CITY OF ST PETERS
636.477.6600
bids@stpetersmo.net

**RE: Addendum 01: Bid 13-139 – Flashing Yellow Arrow
(Federal Project No. CMAQ- 7305 (607))**

This Addendum, consisting of 3 pages, including the attached Revised Drawing, is issued to modify, explain or correct the original Contract documents as noted below, and is hereby made a part of the Contract documents.

4. Section M – Page 126 (M-29), Mid Rivers Mall Drive and Grand Teton Drive –

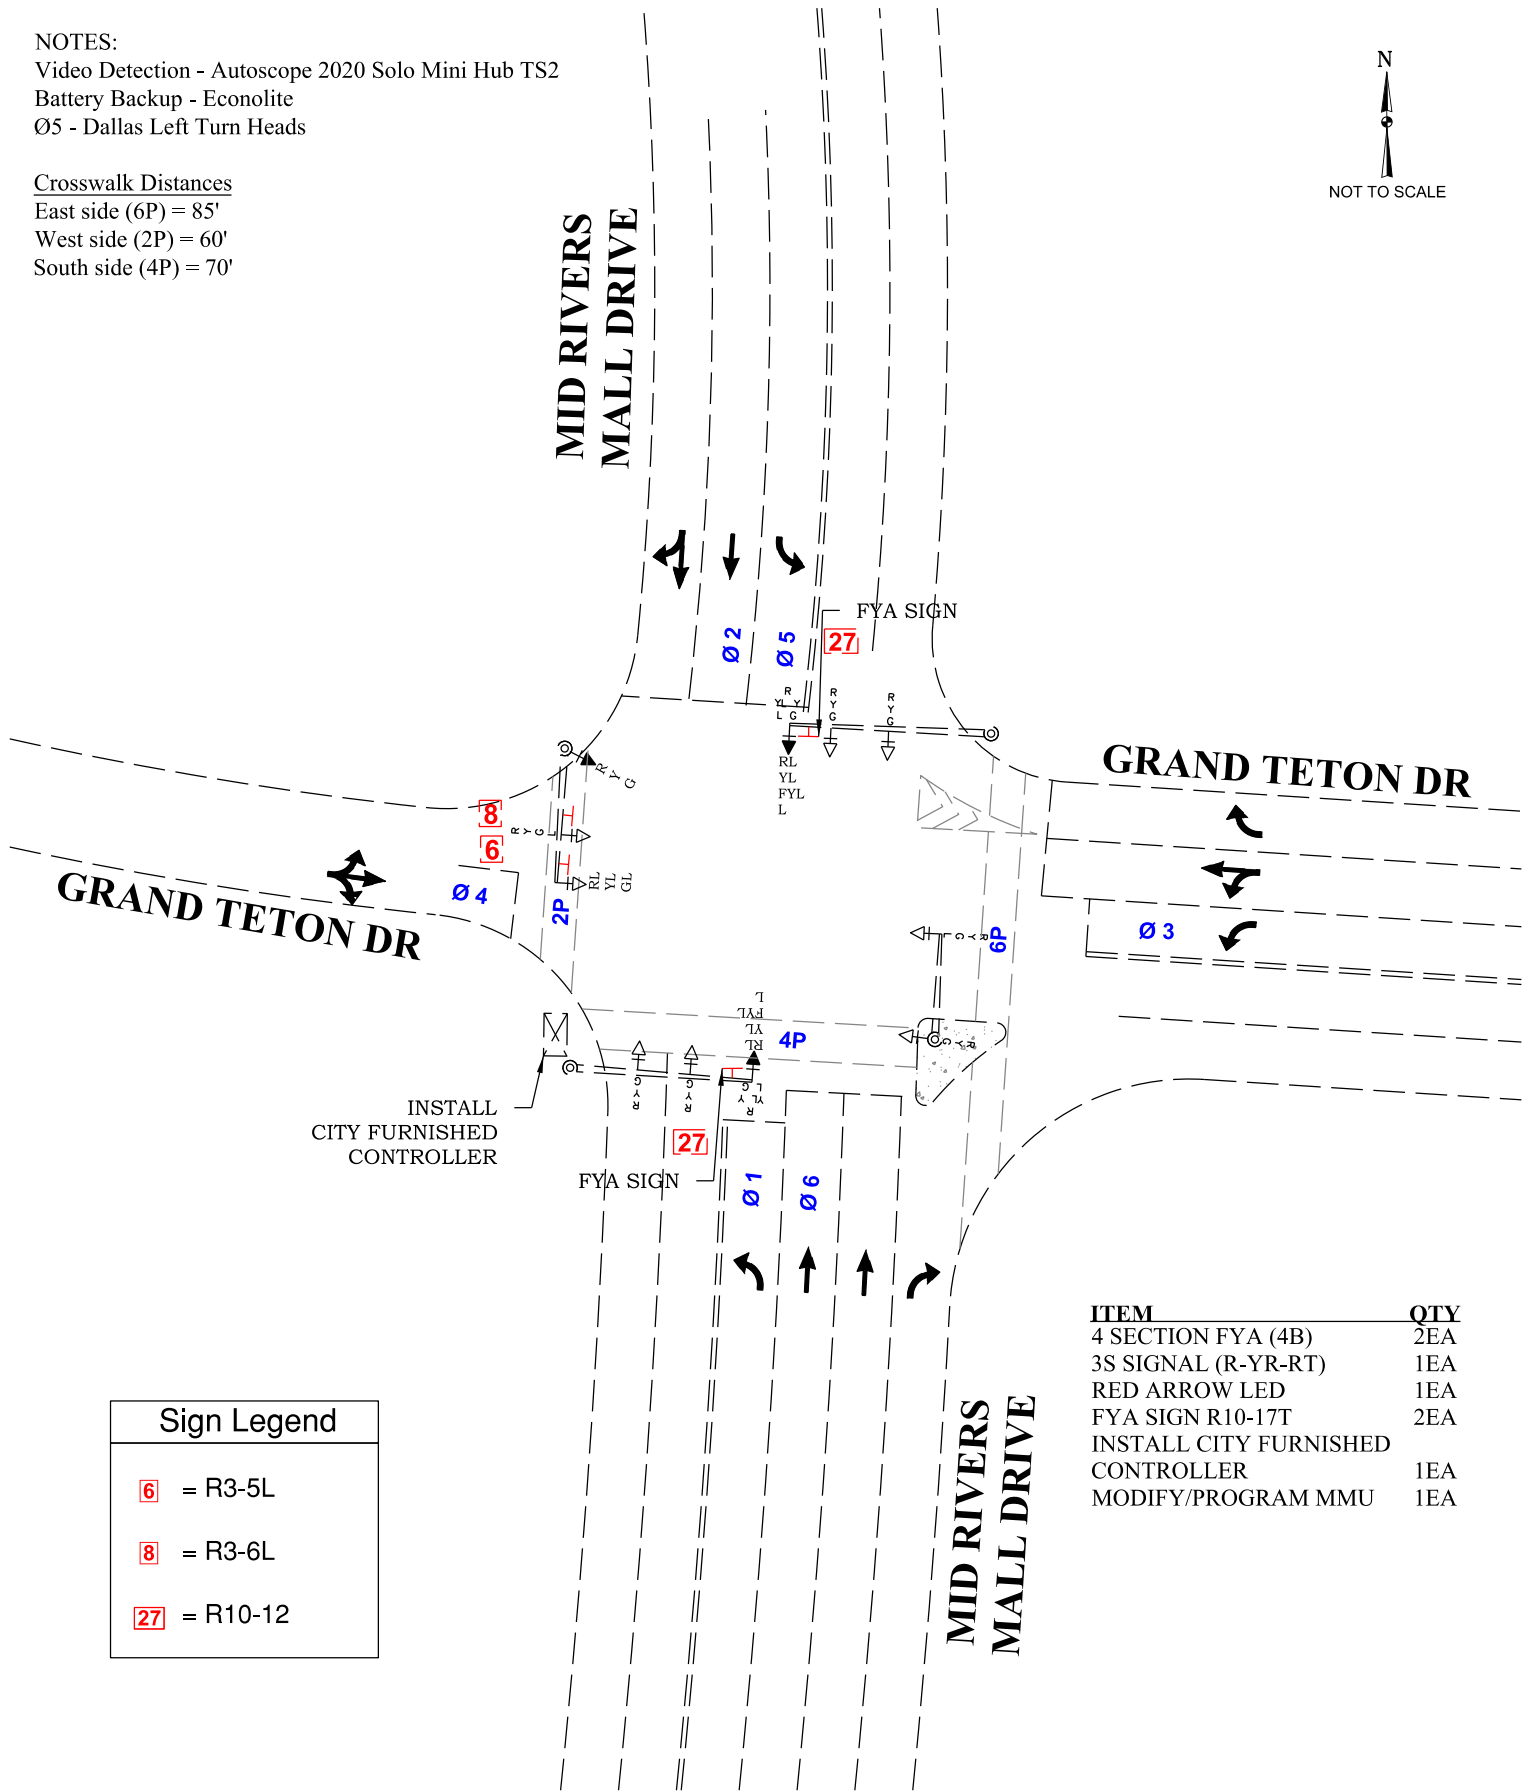
REPLACE Page 126 (M-29).

Mid Rivers Mall Drive and Grand Teton Drive – **REVISED (attached)**

ITEM	QTY
4 SECTION FYA (4B)	2EA
3S SIGNAL (R-YR-RT)	1EA
RED ARROW LED	1EA
FYA SIGN R10-17T	2EA
INSTALL CITY FURNISHED CONTROLLER	1EA
MODIFY/PROGRAM MMU	1EA
